主旨: Fw: (Update) S.16 Planning Application No. A/YL-KTN/1289
附件: AYL-KTN 1289 20260930.pdf

Comments from Drainage Services Department

Temporary Warehouse (Excluding Dangerous Goods Godown) with Ancillary Facilities and Associated Filling of Land for a Period of 3 years at Lot 1864 (Part) in D.D. 107 and Adjoining Government Land, Kam Tin, Yuen Long, New Territories

(Application No.:A/YL-KTN/1289)

D02

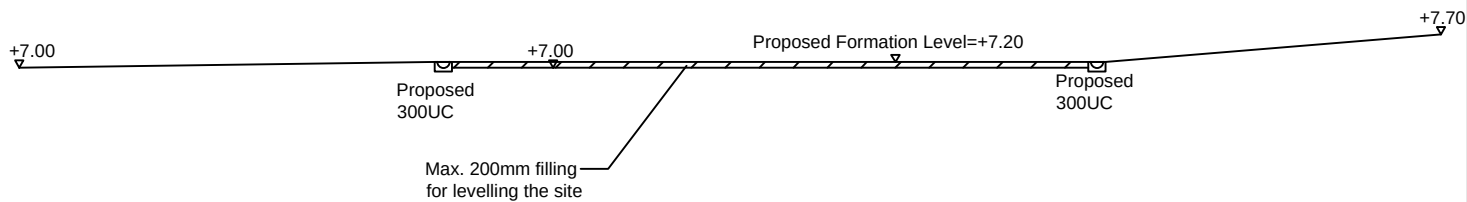
(a) Drawing No. D02: The existing 1000 (W) x 750 (D) open channel is missing in Section A-A. Please update. **Section A-A is revised accordingly.**

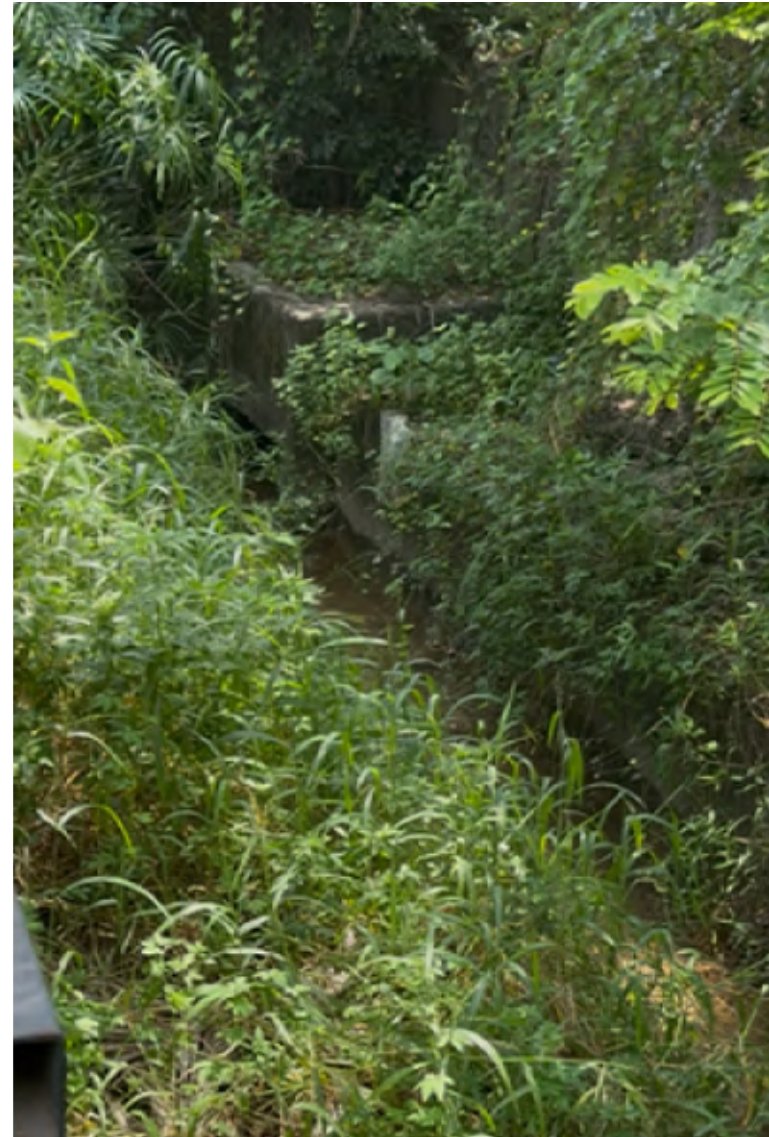
(e) The submitted drainage plan did not reflect current condition of the existing drain, to which the applicant proposed to discharge the stormwater from the application site. Only portion of existing drain adjacent to the application site was found on site. Downstream of the existing channel could not be found on site and might be disturbed by Concrete paving material. The applicant should ensure stormwater from the application site could be properly discharged to the ultimate discharge point (e.g. a well-established stream course/public drainage system). Proposal for any necessary diversion of existing drain(s) Should be submitted by the applicant and designed to the satisfaction of this Division or the Town Planning Board and such agreed diversion works should be carried out by the applicant at the cost of his/her project. Sufficient allowance for future maintenance of the existing drain(s) should be provided. The applicant should review the discharge path and clearly indicate its full alignment from the application site all the way down to the ultimate discharge point (e.g. a well-established stream course/public drainage system) on the proposed drainage plan. The applicant should provide site photos to demonstrate

the presence and reflect condition of the existing drainage system. **Site inspection was carried out on 4-9-2026. The full flow path of the existing drains in the north is identified (Photo 13~16 are provided)**

C2406 /2B

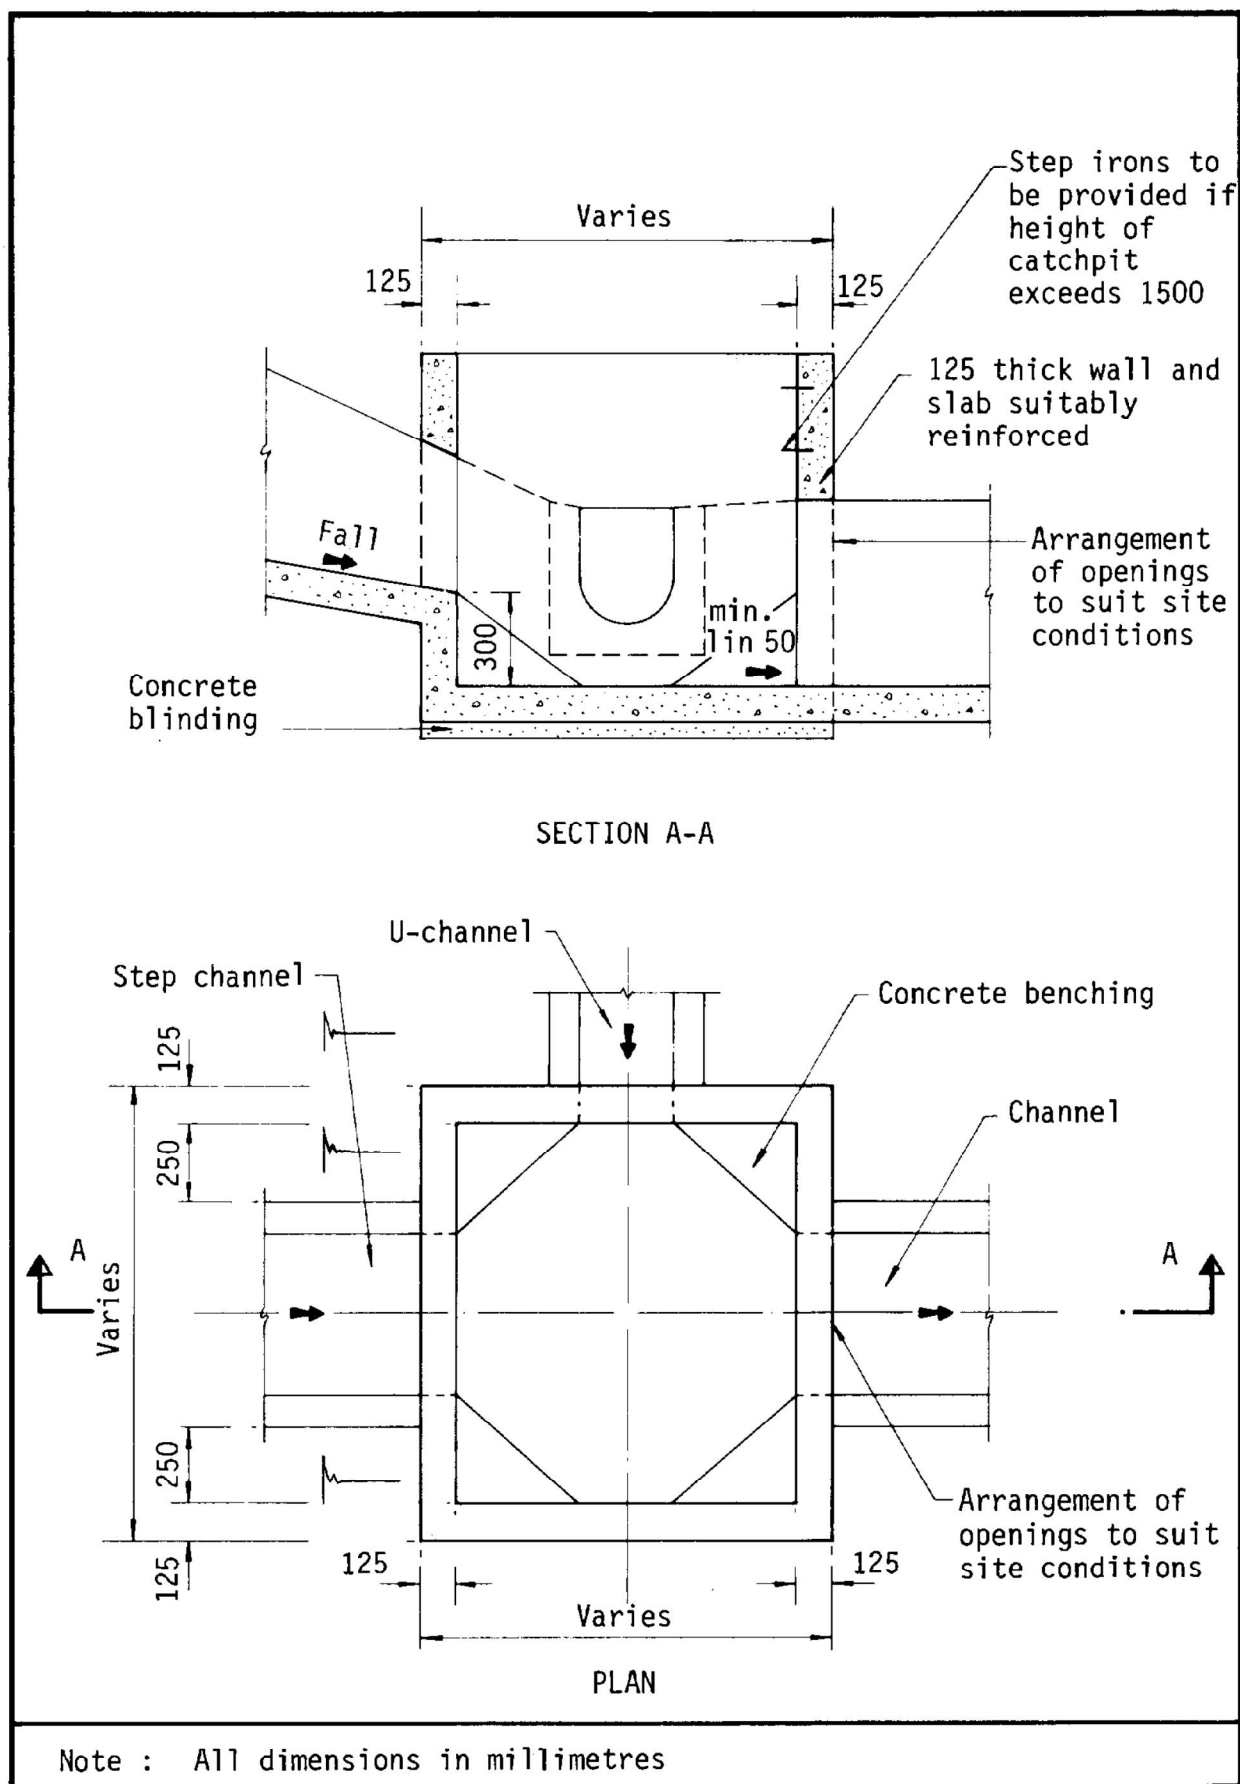
(j) Drawing (No; C2406/2) was not up-to-date. **Updated Drawing (No; C2406/2) is provided.**

Proposed Stormwater Collection System of
A/YL-KTN/995, 1181 and 1167

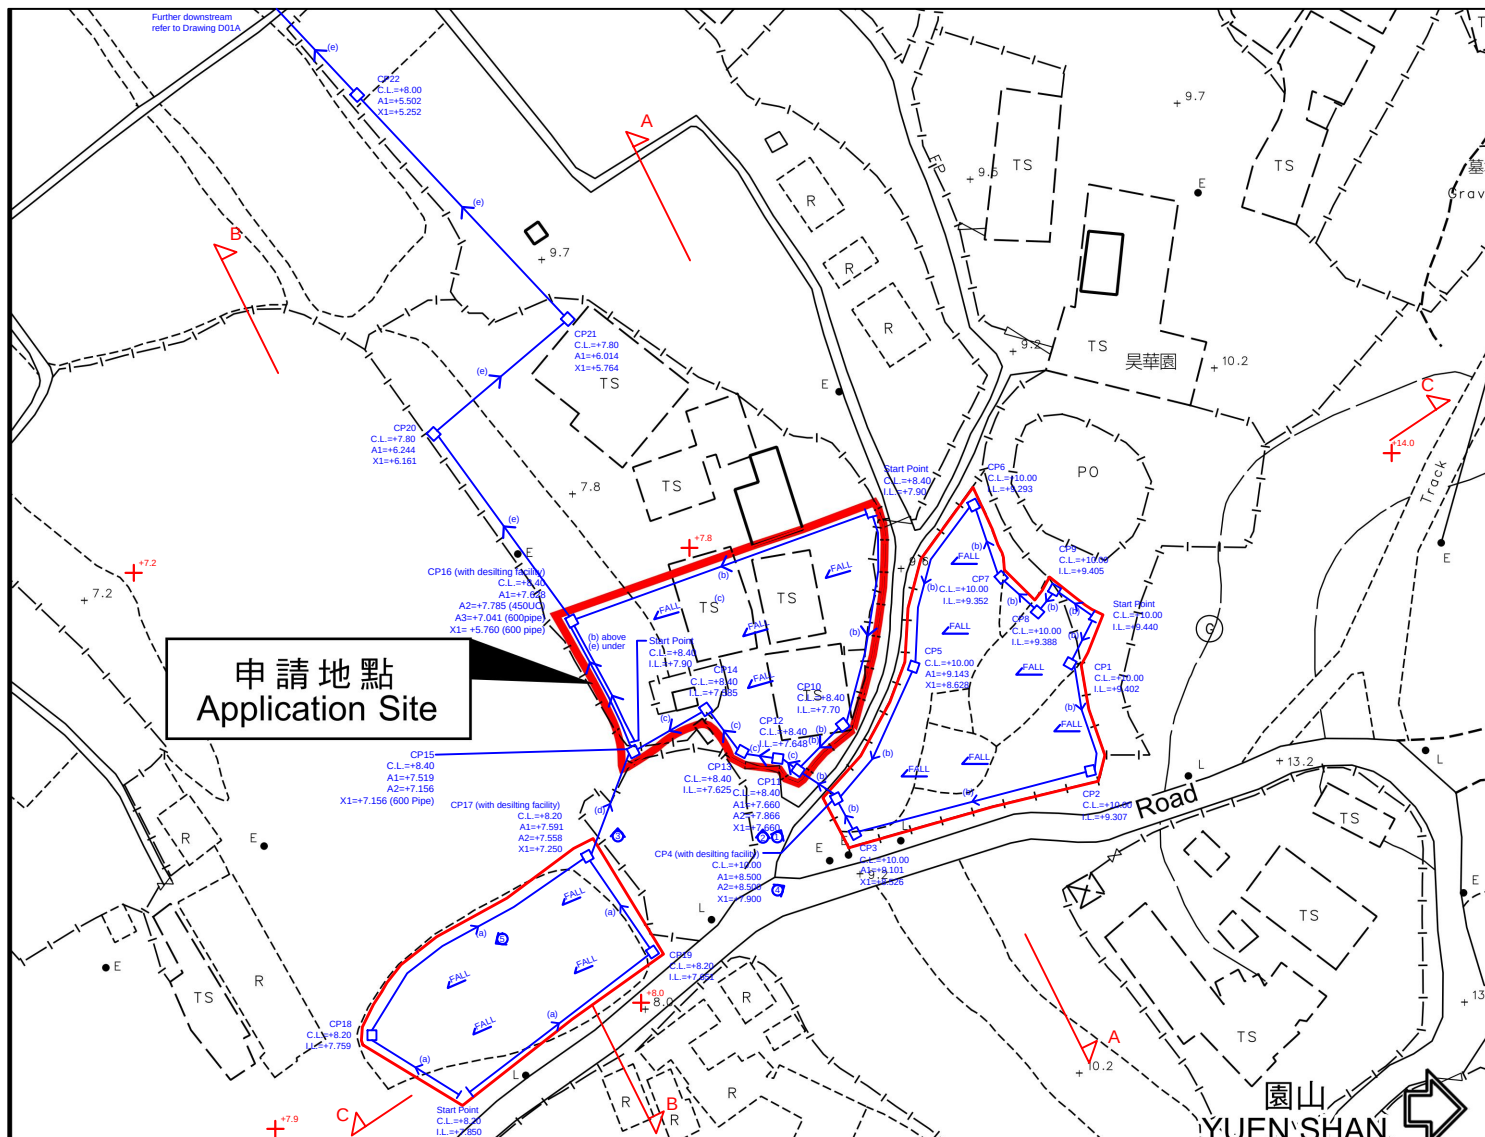
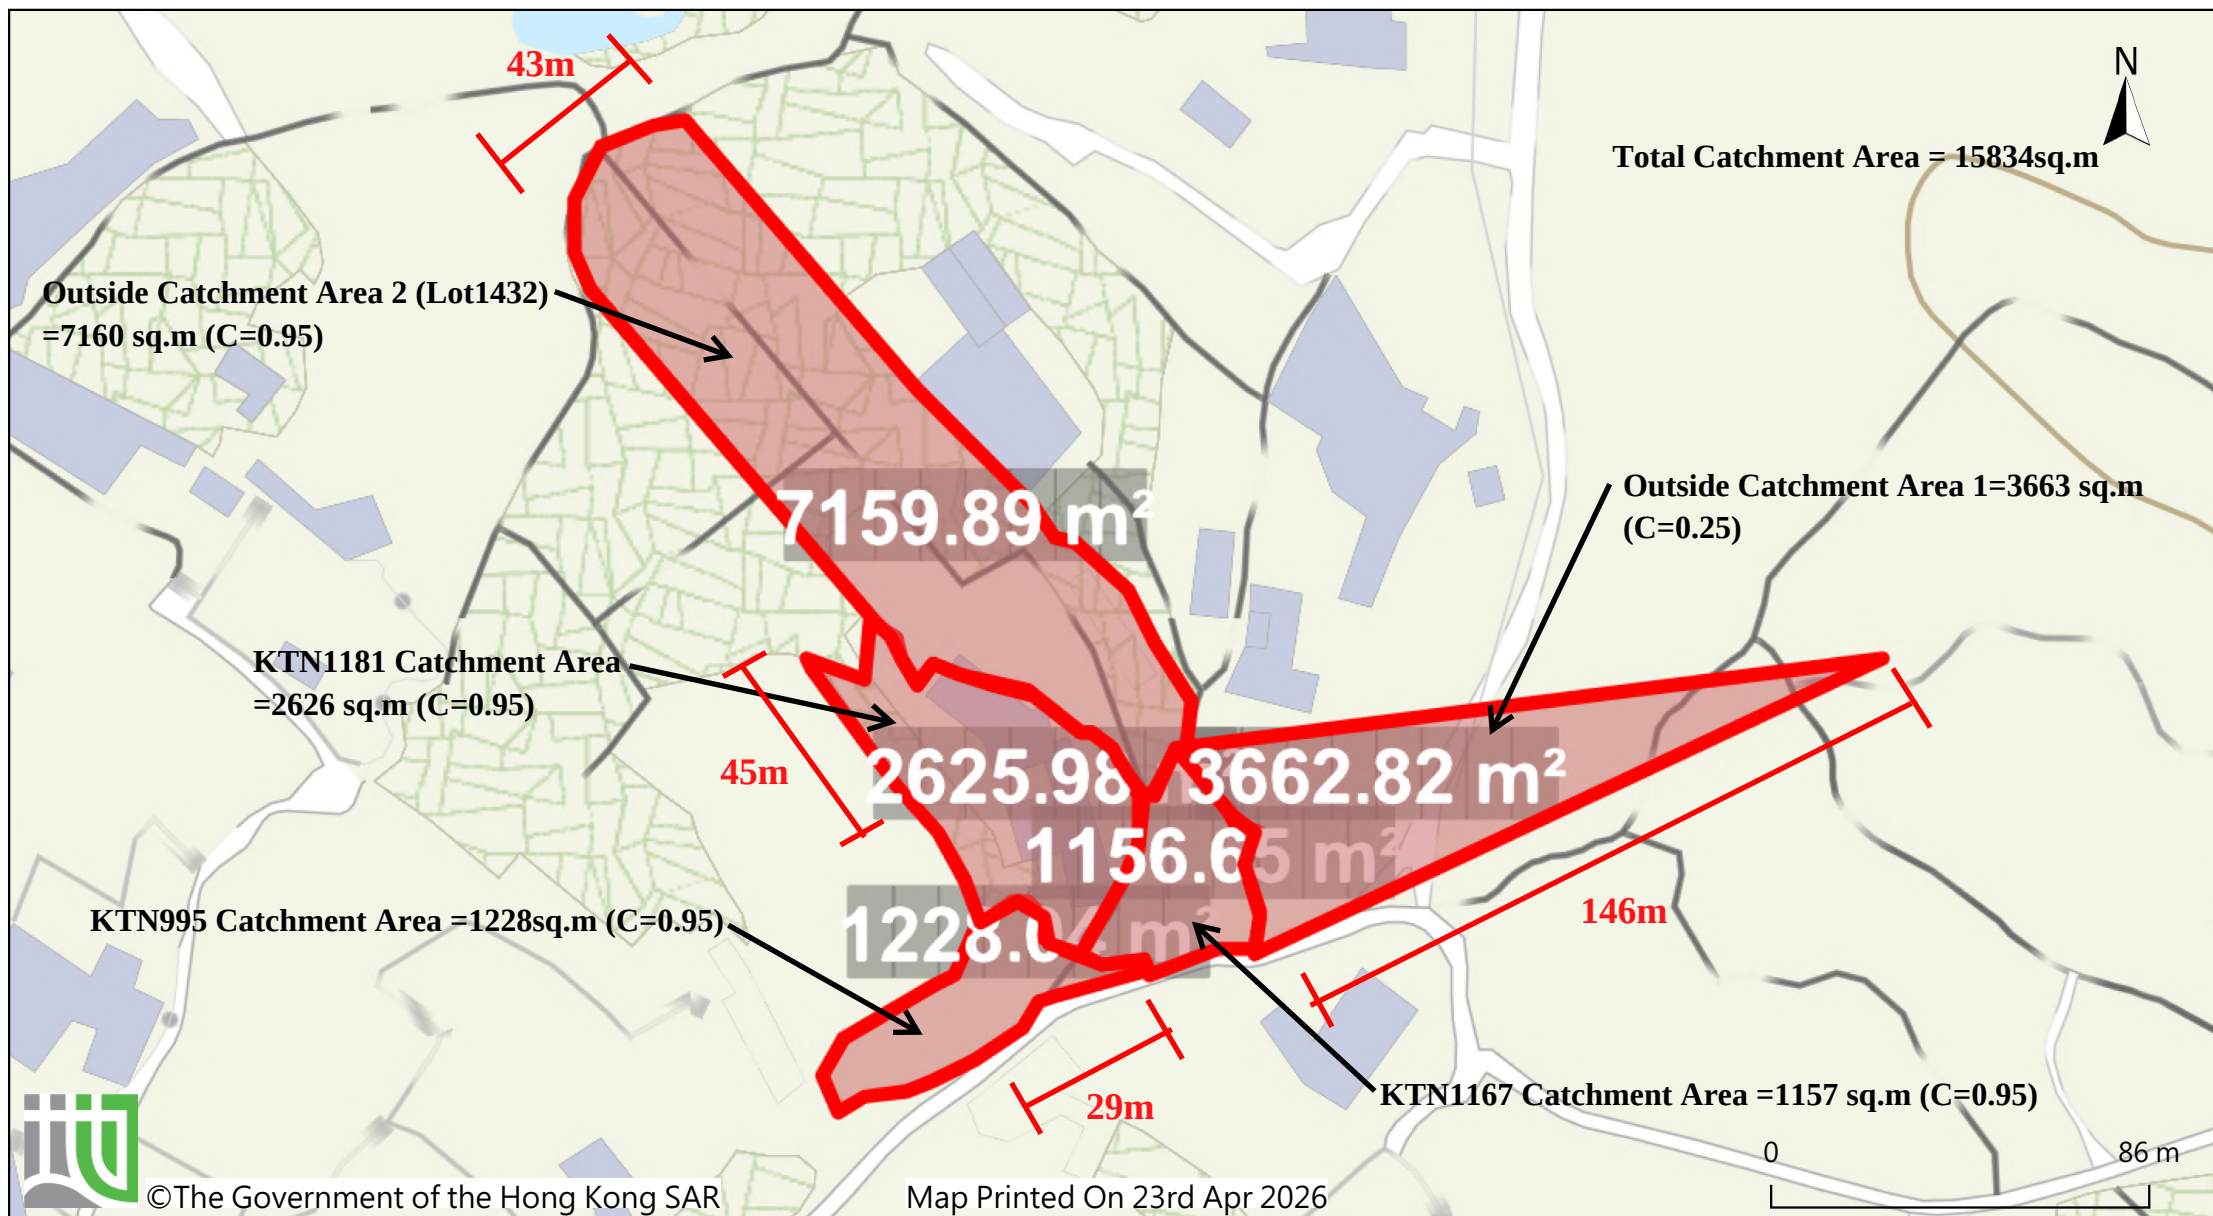
(b) Please supplement the details of the stormwater collecting system of A/YL-KTN/995, 1181 and 1167 for reference. **It is provided in Appendix A.**

Inspection Record (inspection date:4-9-2026)

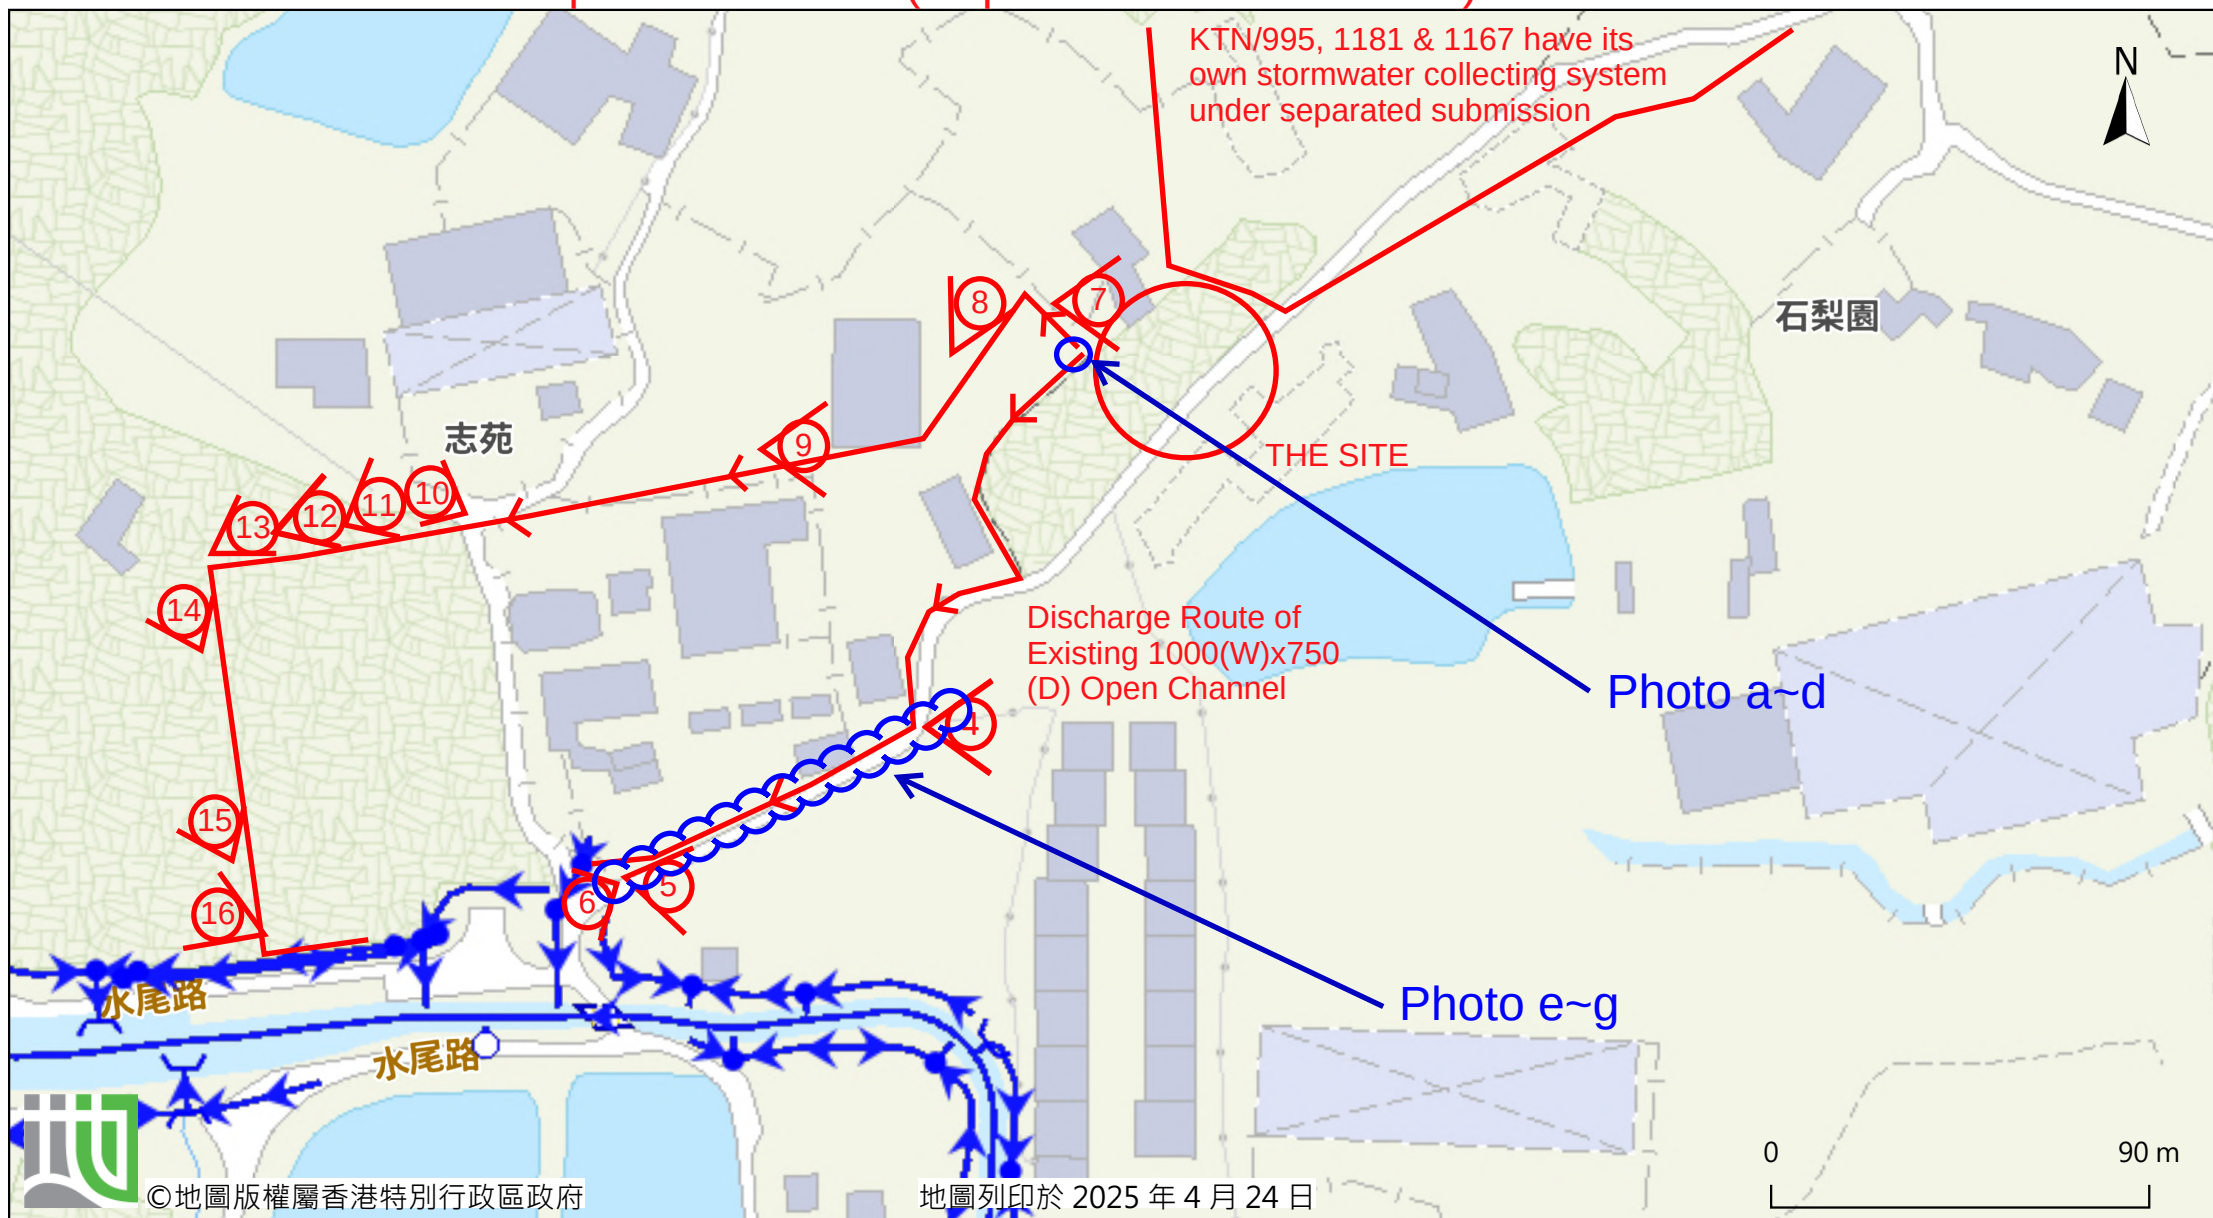
(d) Please demonstrate that the open channel as shown in Photo 4 is not an isolated channel, i.e. demonstrate the existence of the drainage pipe or U-channel between the site and viewpoint 4. **Site inspection was carried out on 4-9-2026. It is found that the open channel as shown in Photo 4 is not an isolated channel because continuous flow was observed (as shown in Appendix B)**
